UNITED STATES PATENT AND TRADEMARK OFFICE

APPLICATION NO.	FILING DATE	FIRST NAMED INVENTOR	ATTORNEY DOCKET NO.	CONFIRMATION NO.
10/089,717	04/02/2002	Robert John Pannekoek	02-313	2705

Office Action Summary	Application No. 10/089,717	Applicant(s) PANNEKOEK, ROBERT JOHN	
	Examiner James M Hewitt	Art Unit 3679

DETAILED ACTION

1,526,336

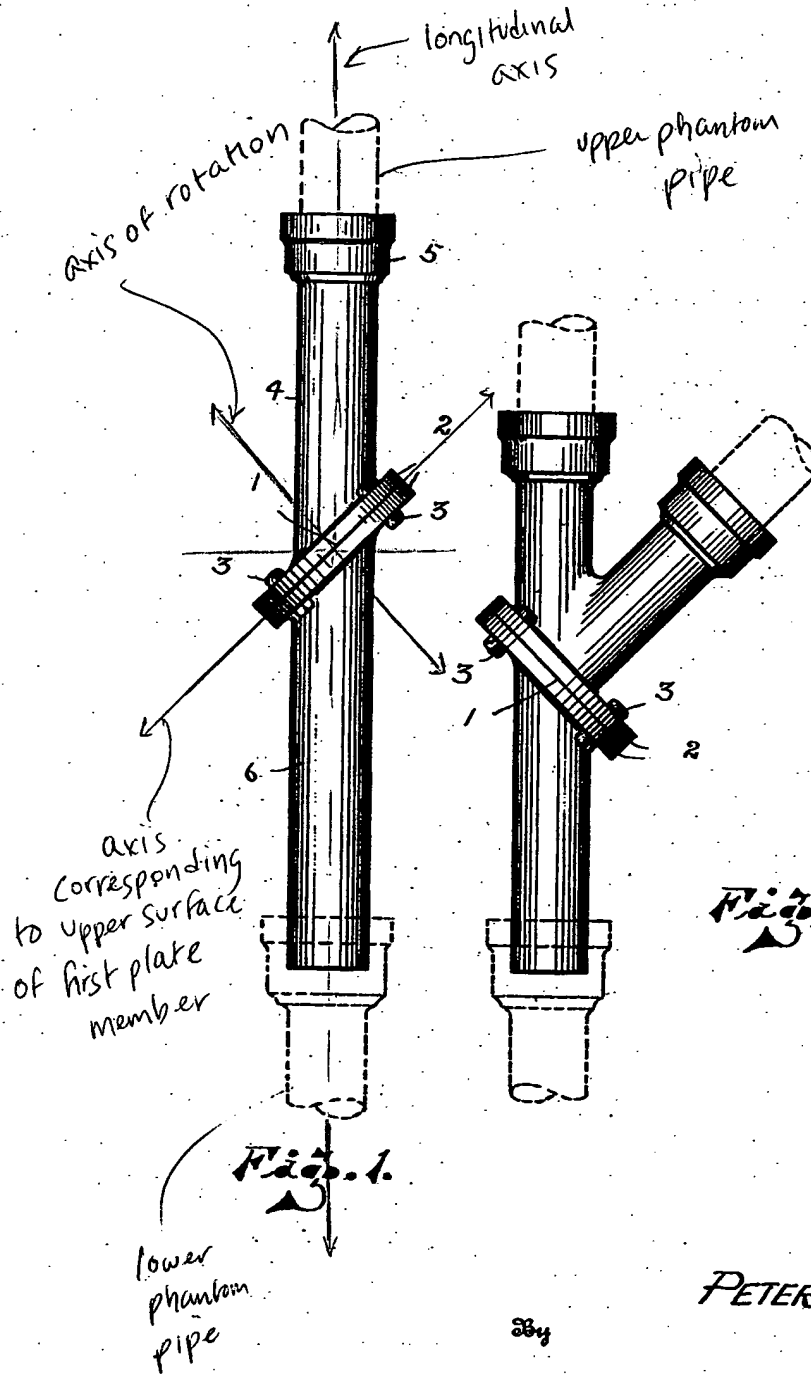
With respect to claim 1, Hart discloses an elongate member for locating an article (in Figure 1, the pipe shown in phantom connected to pipe section 4) remote from a base position (in Figure 1, defined by the pipe shown in phantom connected to pipe section 6), characterized in that the elongate member comprises an inner elongate portion (6), the inner elongate portion extending, in use, from the base position, an outer elongate portion (4), the outer elongate portion being arranged to receive the article, and interconnecting means (flanges 2 and bolts 3), the interconnecting means being arranged to connect the inner elongate portion to the outer elongate portion and to permit relative rotation of the inner and outer portions about an axis of rotation (see Attachment A), the axis of rotation being disposed at an acute angle (45 degrees; see lines 52-53) relative to a longitudinal axis (see Attachment A) of the inner elongate portion.

Elongate portion (6) is considered to be "inner" in that it is situated more closely to the lower pipe shown in phantom. Elongate portion (4) is considered to be "outer" in that it is situated further from the lower pipe shown in phantom relative to portion (6).

Loosening or removal of bolts (3) would permit relative rotation of the inner and outer portions about the axis of rotation.

With respect to claim 2, wherein the outer elongate portion (4) is arranged to move between a first position (shown in Figure 1) whereby the outer elongate portion is substantially coaxial with the inner elongate portion and a second position whereby the outer elongate portion is substantially perpendicular to the inner elongate portion.

The outer elongate portion, after loosening or removal of the bolts (3) and rotating the outer portion and its flange 180 degrees relative to the inner portion and its flange, would be oriented perpendicular to the inner elongate portion. The bolt holes, as they are symmetrical about their respective flanges (2), would be aligned, and the bolts could be re-engaged therein to secure the outer elongate portion to the inner elongate portion.

With respect to claim 4, wherein the interconnecting means includes a first plate member (flange 2) fixedly attached to the inner elongate portion (6) at an end remote from the base position, and a second plate member (flange 2) fixedly attached to the outer elongate portion (4) at an end remote from the article wherein, in use, the first plate member is located adjacent the second plate member (see Figure 1).

With respect to claim 5, wherein the first plate member has an upper surface and the second plate member has a lower surface, the upper surface of the first plate member being adjacent the lower surface of the second plate member in use, and the axis of rotation being perpendicular to the upper surface of the first plate member (see Attachment A).

FIG. 2

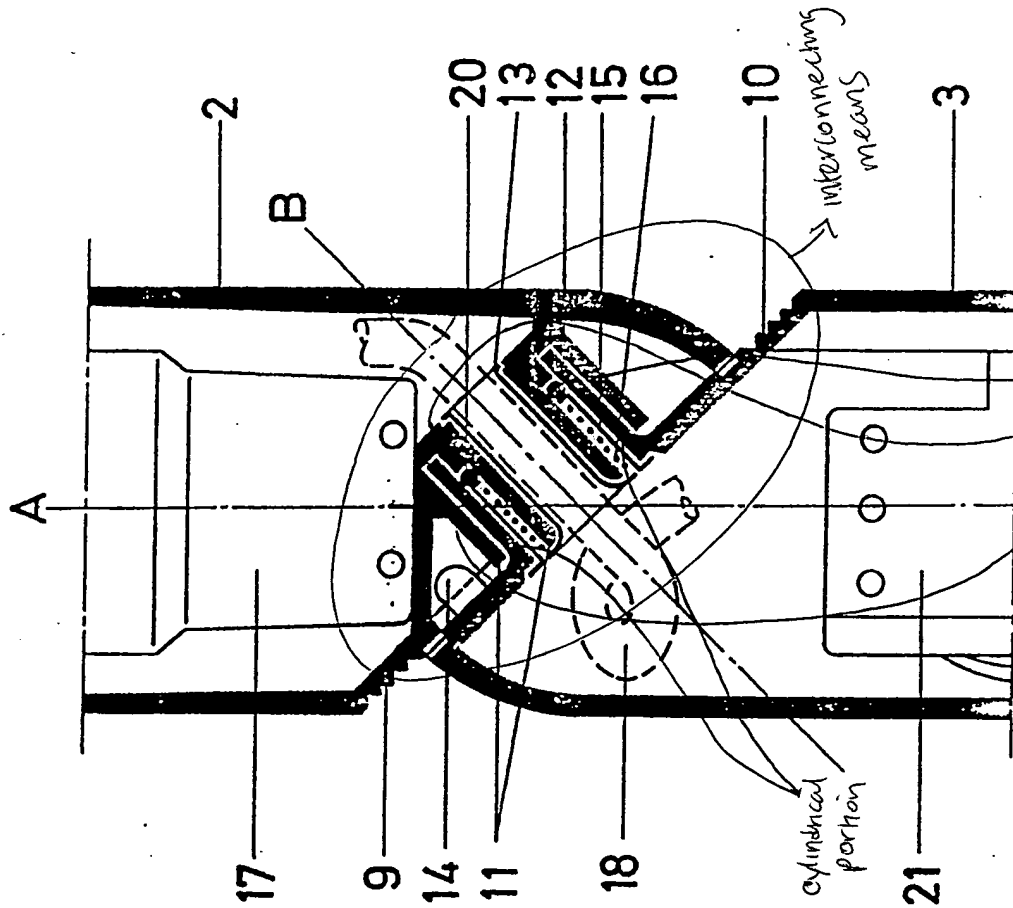
With respect to claim 10, wherein the interconnecting means includes a cylindrical portion arranged to be coaxial with the axis of rotation, and wherein the cylindrical portion extends from the inner elongate portion and wherein the outer elongate portion includes an aperture arranged to receive the cylindrical portion. Refer to Figure 2 and Attachment B.

this structure forms an aperture which holds/houses the cylindrical portion
